# [MJFAS] 1479 : Interim Decision
1 message

Article Id : MJFAS 1479
Title: Temperature-dependent Kinetics of Aluminum Leaching from Peat Clay

Response to Reviews

**Fig. 2** The mechanism of aluminum leaching of the SC model.

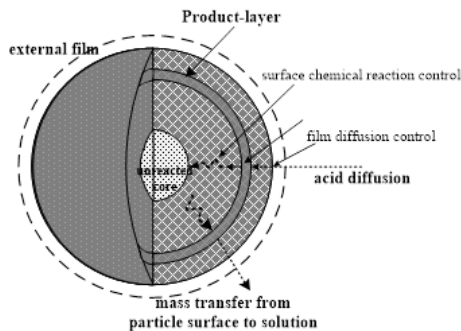
3.    The description will be more interesting if author add mechanism of leaching by picture in the manuscript.

3. The description will be more interesting if author add mechanism of leaching by picture in the manuscript.
Response:
Authors agree with Reviewer and we are grateful for the for the suggestion. Based on Mirwan et al. 2017, the mechanism of aluminum leaching was showed in Fig 2.

**Fig. 2** Aluminum recovery from experimental data and model curves

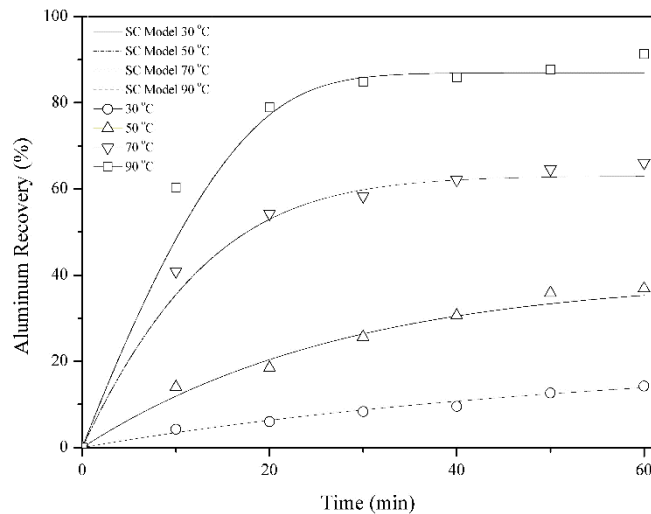
General comments to author/editor:
    1. The kinetics was developed from scientific equations. Are all the equation creating by the authors or taking from some sources? No information about it.
2. The image was not so clear, specially for the line of the SC Model with different temperature (Fig. 2)
3. I am a bit confuse with the conclusion. In conclusion, authors mentioned:
a. "...that the aluminium leaching from peat clay was occurred in two stage:...". I cannot found any statement that explain or supporting this conclusion in result part. So that, how to draw this conclusion?
b. "...kinetics parameter provides good concept of mass transfer phenomena...". The same with point a, I cannot found any statement about the relationship between kinetics parameters and mass transfer phenomena for this case.

2. The image was not so clear, specially for the line of the SC Model with different temperature (Fig. 2)
   Response:
   Authors are grateful for the comments. To make it clearer, we did make a figure to better illustrate the SC model as following.
